The meeting was called to order at 6:00pm by Planning Chairwoman Karen Gautreaux

**V23-02-03** – Juan Fonseca requests a variance to CLURO Section 8.1.3. Supplemental Fence and Wall Regulations, Square H Lot 99A, R-1 Single Family Residential District, 499 Devon

Re: Case Number: V23-02-03  
499 Devon Drive  
Height Variance to CLURO Section 8.1.3. Supplemental Fence and Wall Regulations

IMAGE 14

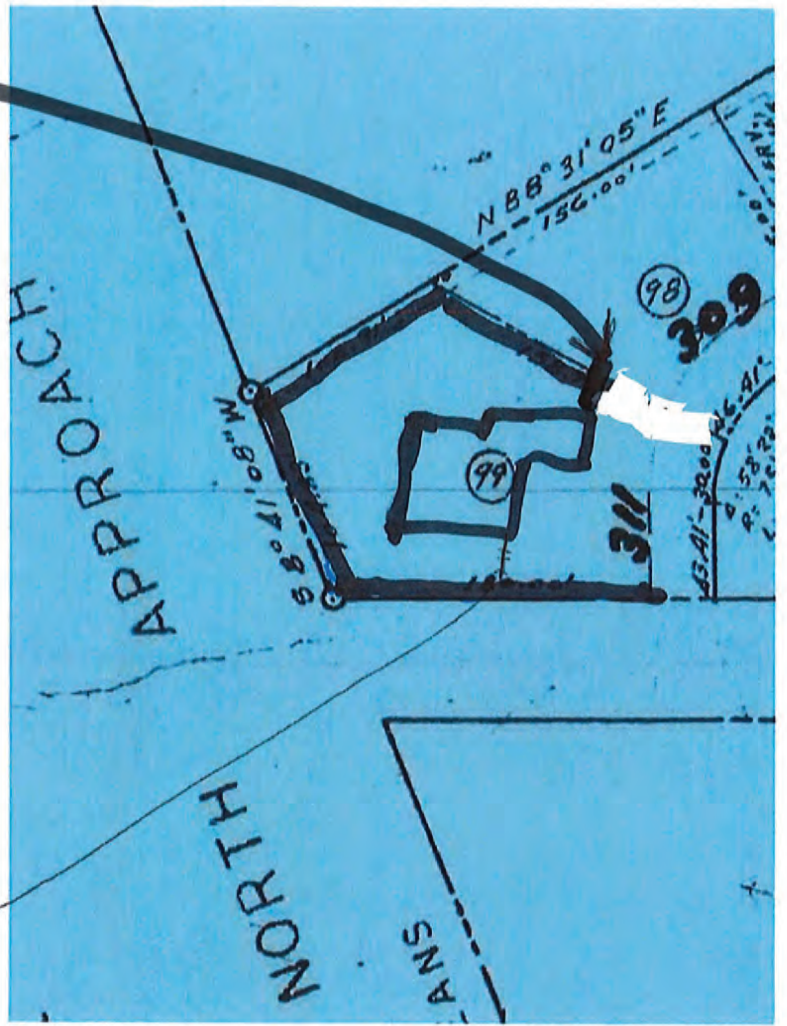
7. The Homeowner began constructing his fence without a permit. When notified by the City that a permit was required for that work, he did apply for the permit, but continued working on the fence and completed his work without receiving a permit or addressing the City's permit review comments. *[Images 14, 15 and 16, attached]*

Fence must be setback 25ft from Devon Dr. Fence cannot exceed the height of the current subdivision fence along Florida Extension and North Causeway. Fence cannot be more than 4ft in height if located in between the front of the structure and front property line. Please submit new sit plan reflecting the required changes
